MIDTOWN COMMONS

SUMMARY OF DRB II RECOMMENDATIONS

2301 East Union Street
Project No. 3028872

Design Recommendation III
03/13/2019

A LANDSCAPE SITE PLAN
N.T.S.

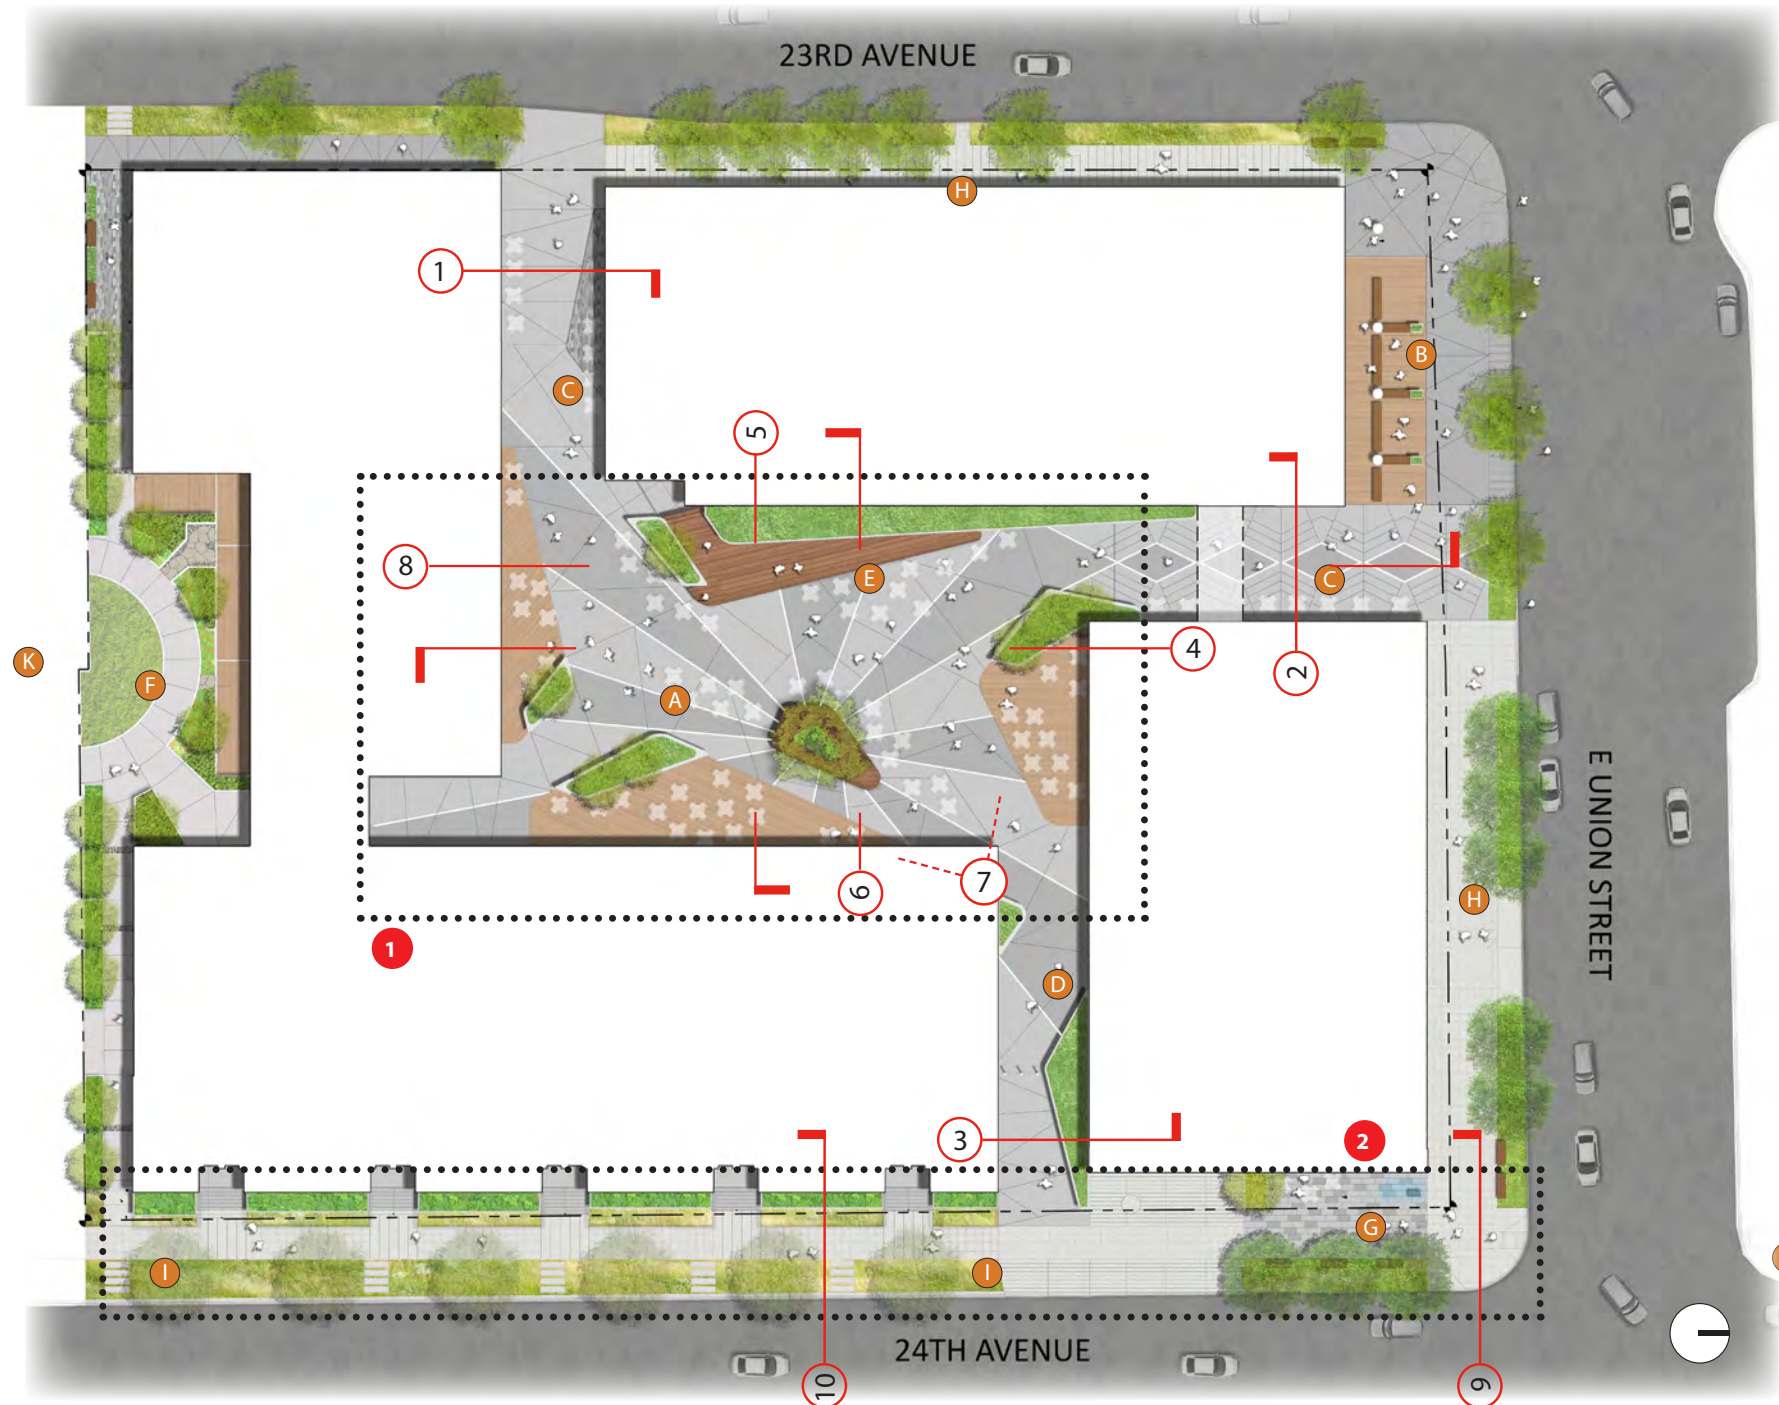
- 1a PORTAL FOCAL POINT-** The Board supported the removal of the sky bridge as it affords a clearer entry point and supports the design intent to draw pedestrians to the courtyard
- i. The Board also noted the potential for a focal point (e.g., a piece of art, the tree) to attract pedestrians to the courtyard and asked that these views from the street be carefully considered.

- We are proposing a collection of trees at the ends of the portal axes, refer to new sections and plan view diagrams.
- The collection of trees at the visual terminus from the street reduce the scale of the building and provide a softer pedestrian scale element to draw patrons into the square.
- Raised planters and wood platforms combine to create a scaled series of ground level elements in combination with the trees and lower level plantings.

PREVIOUS WEST ELEVATION - NORTHWEST BUILDING 1b

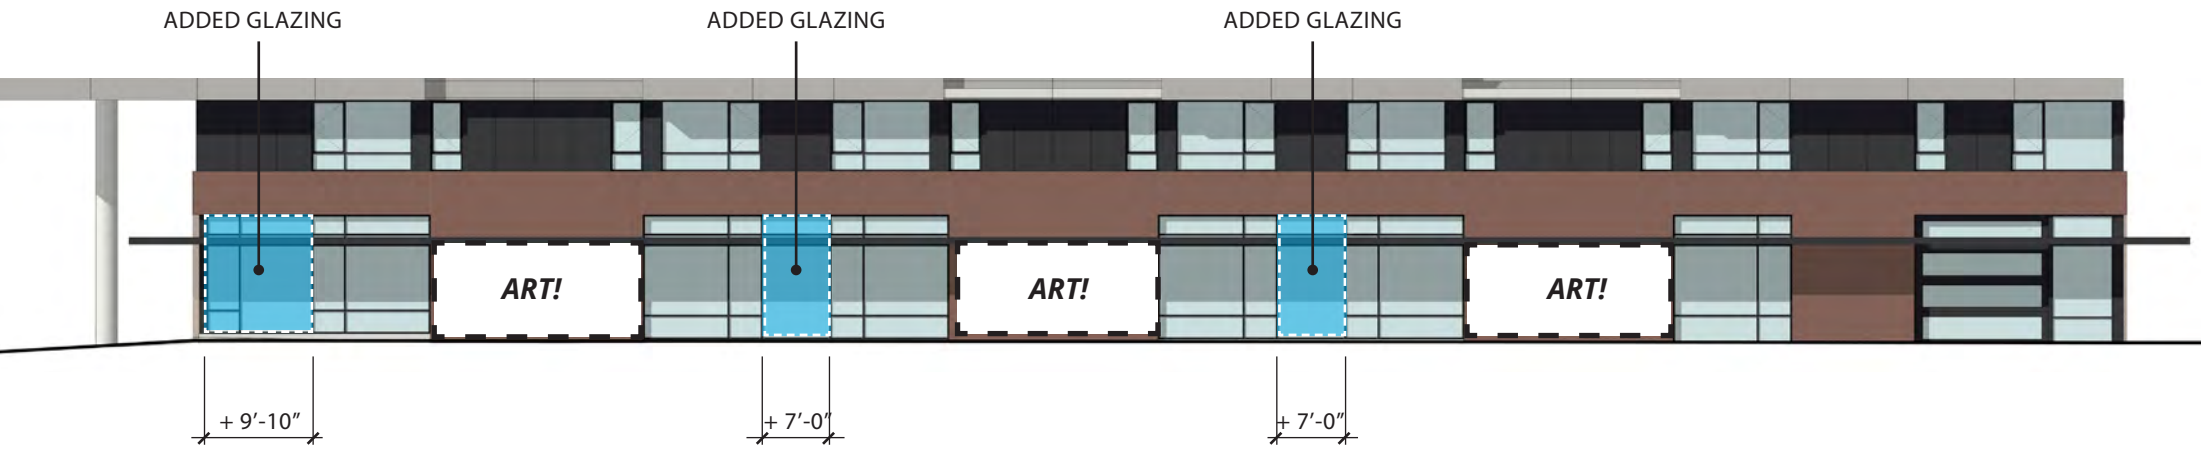
1b FACADE TRANSPARENCY- The Board echoed public comment and their guidance from the previous Recommendation meeting (below) that the street edge lacked the degree of transparency required to make this an engaging edge.
CS2-B-2, PL3-C, PL2-I-ii

- Sections of masonry have been replaced with storefront glazing to increase transparency. Glazing now meets code requirements.

1d

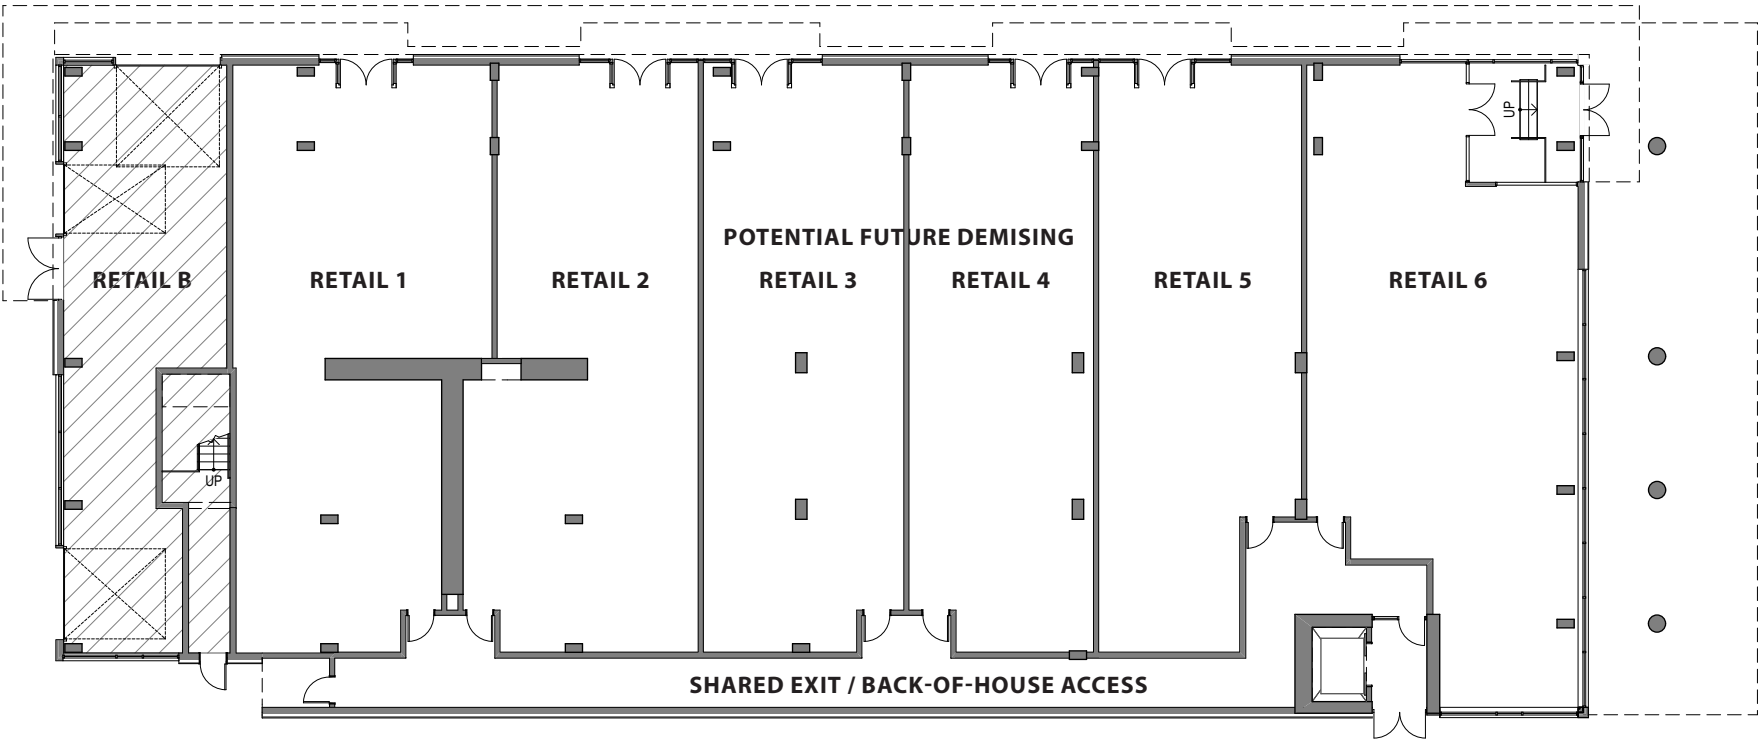
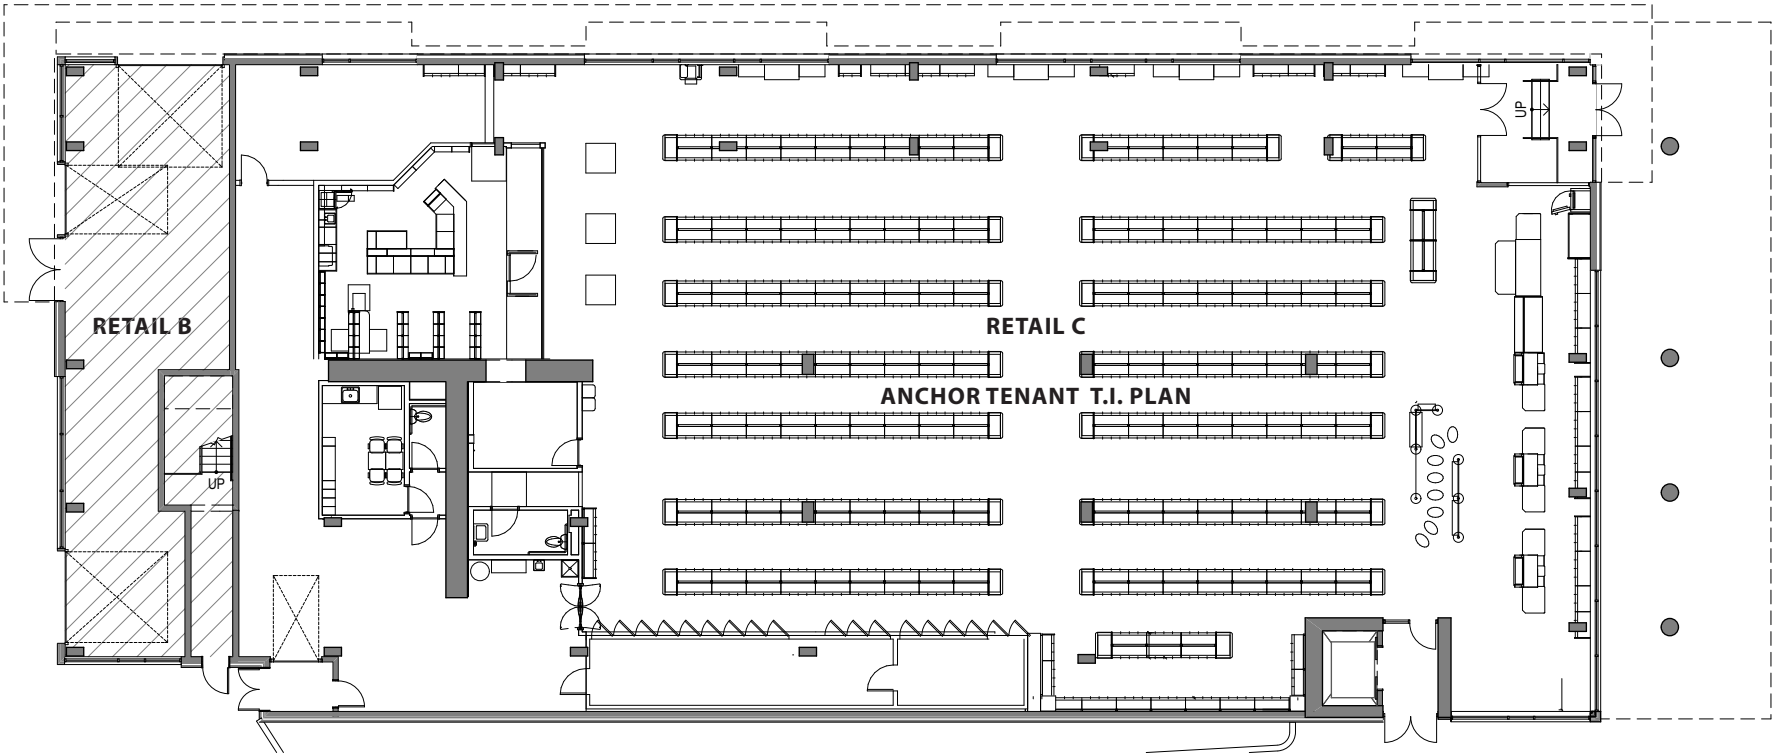
1c TRANSPARENCY- The Board noted their previous recommendations related to concerns regarding the 23rd windows and logical locations for entries to accommodate a variety of business uses and sizes (EDG Packet, p. 59). At the last Recommendation meeting, the percentage of glazing on this façade had been significantly reduced and replaced with brick panels. The Board did not support this change as it decreased the porosity and visibility they had encouraged at EDG. Furthermore, it was unclear how the retail space at this northwest corner might be further divided in conjunction with the façade treatment. The Board requested that composite floor plans be presented at the next meeting demonstrating how this space might be further divided in consideration of the 23rd Avenue façade.

1d ENTRANCES- The board also asked that multiple entrances (or provisions for them) be included to allow for the future subdivision of these spaces for smaller retail businesses

- See diagram 1d for potential future demising.
- Sections of masonry have been replaced with storefront glazing. See diagram 1b on opposite page.

- The masonry between glazing provides the opportunity to re-demise the space into smaller businesses with separate entrances. The storefronts can be modified in the future to insert entry doors.

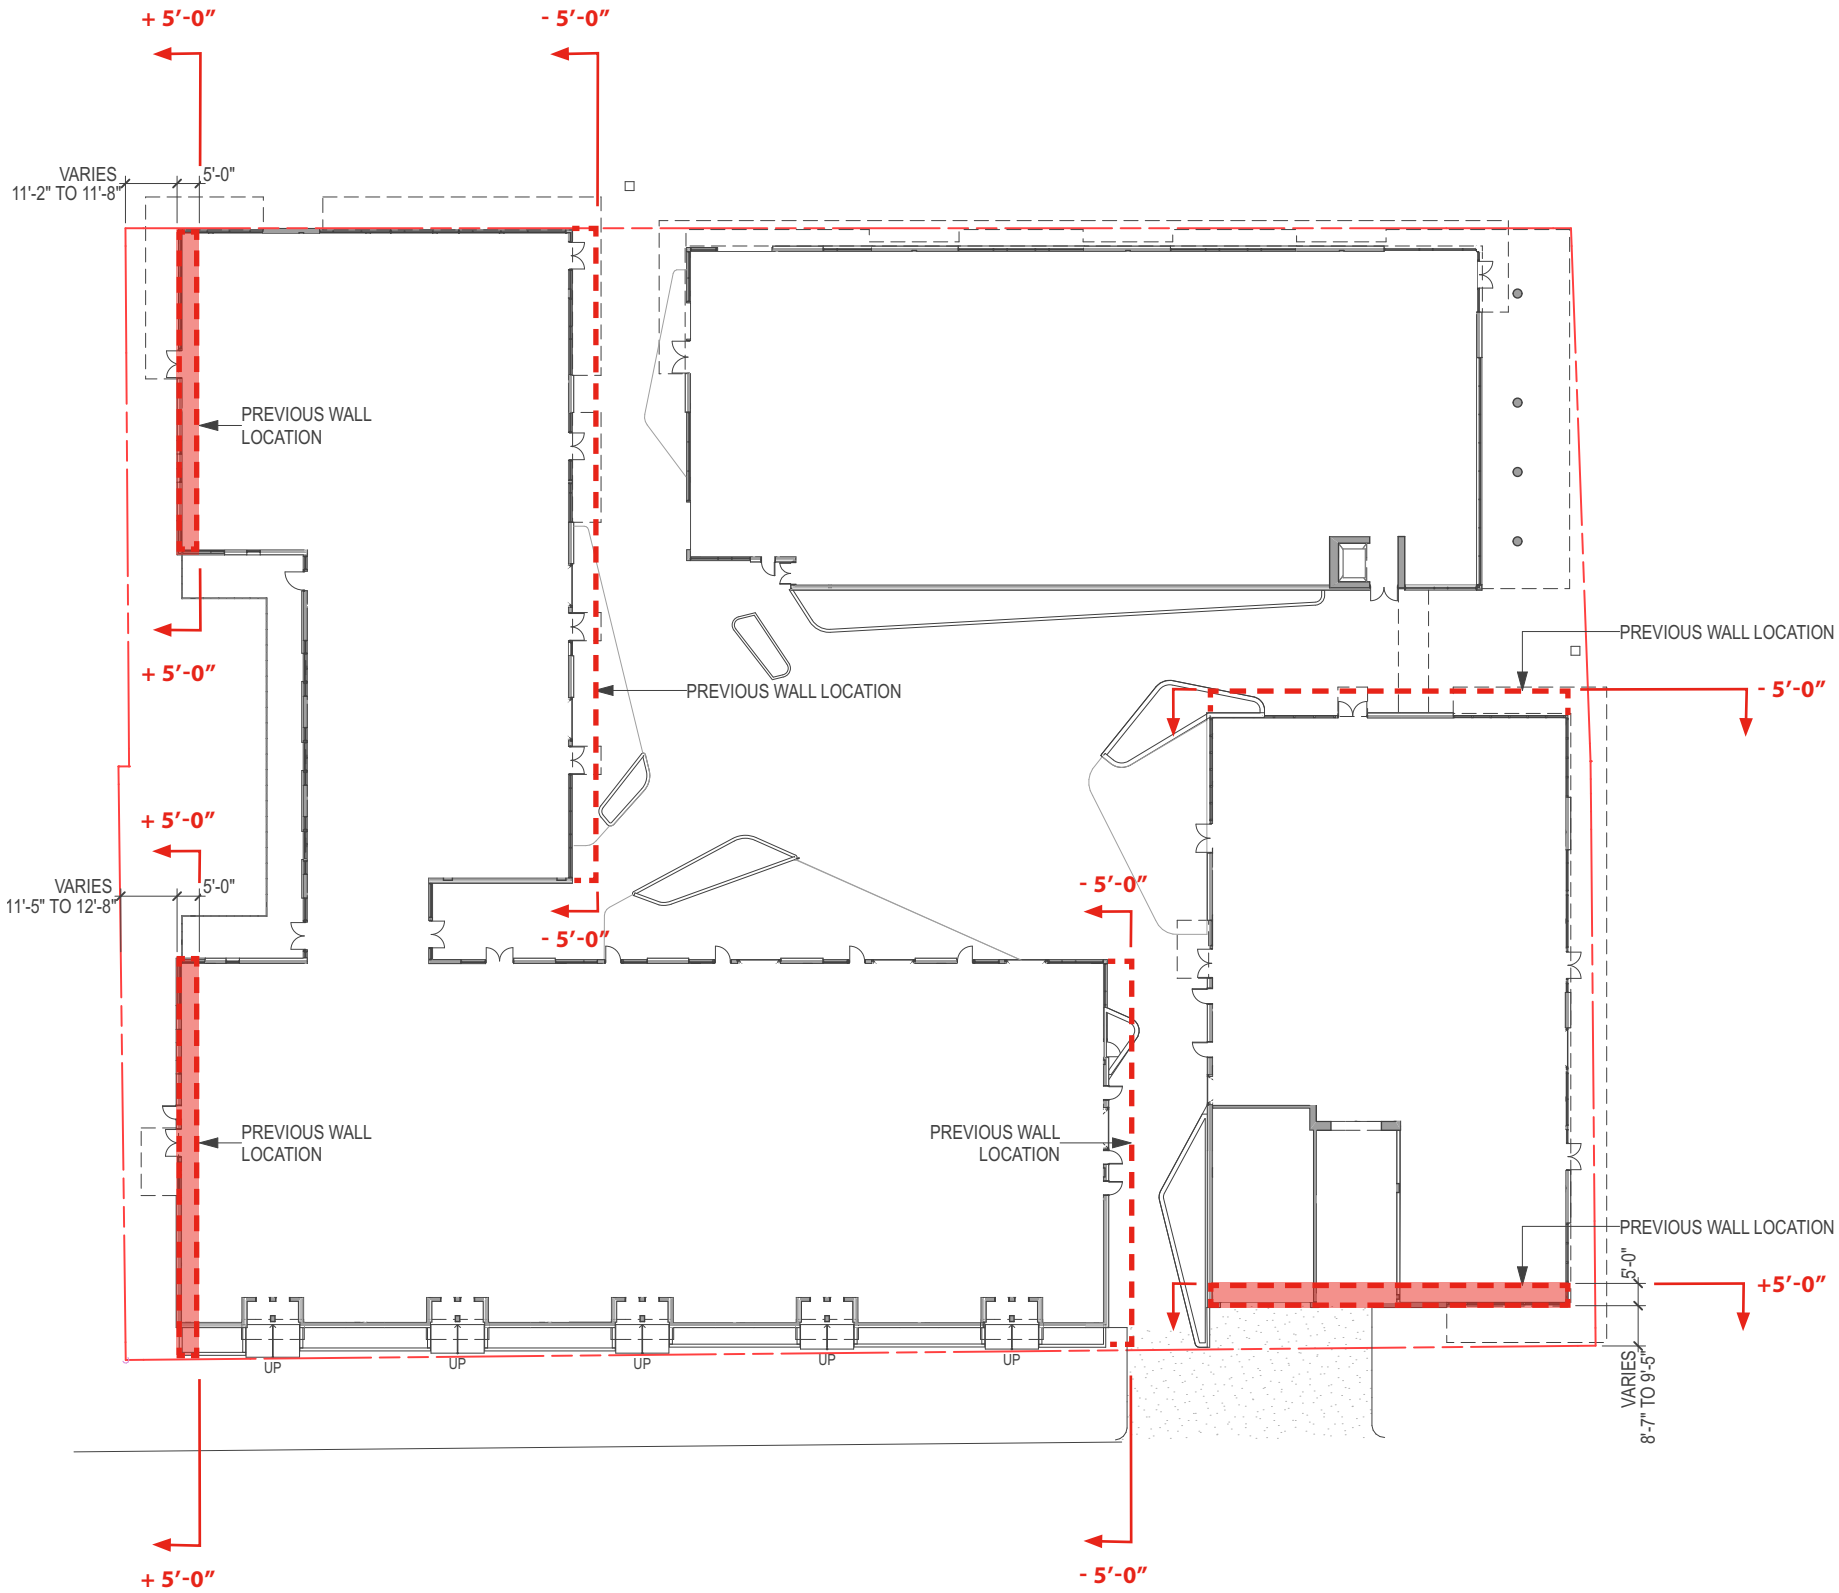
EAST UNION STREET PORTAL- The Board supported the five-foot increase in the width of this passage, noting their appreciation of this direct response to their previous guidance.
- iii. Staff note: It was somewhat unclear that this shift had reduced the size of the area at 24th and Union (rather than the courtyard.) Please make this shift clear in the new documents.

- iii. This diagram shows how the corner is impacted by the increase in portal width.
